PLAT COMMITTEE June 14, 2023

Case Number: 2023-PLT-023

Reguest: Approval of a Subdivision Plat to be known as Anderson / Richardson

Southeastern Avenue Minor Subdivision, dividing 1.79 acres into two lots.

Plat Detail

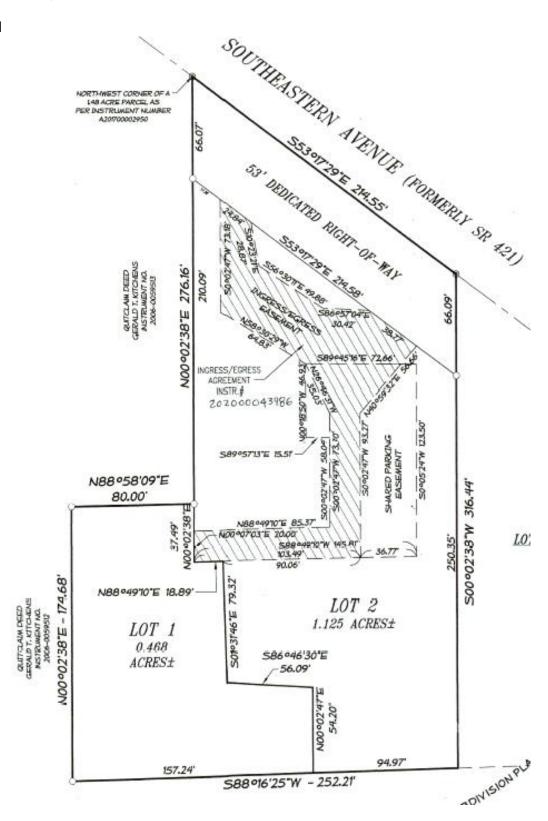
This site is split-zoned C-3 and C-7, and is developed with four commercial buildings and accessory structures, and related parking. The proposed plat would subdivide the property into two lots. Lot One would contain the southwest portion of the site containing two buildings and accessory structures. Lot Two would contain the eastern portion of the site with frontage on Southeastern Avenue, Lot Two would contain the multi-tenant building, and the building directly to the south. The proposed plat meets the standards of the C-3 and C-7 zoning classification.

Lot Two would front on Southeastern Avenue to the north. Since this is an integrated commercial property, Lot One would have access to the Southeastern Avenue frontage via access easement as shown. No new streets are proposed as part of this petition.

Sidewalks are required along Southeastern Avenue.

Staff recommends that the Plat Committee **approve** and find that the plat, file-dated March 27, 2023, complies with the standards of the Subdivision regulations, subject to the following conditions:
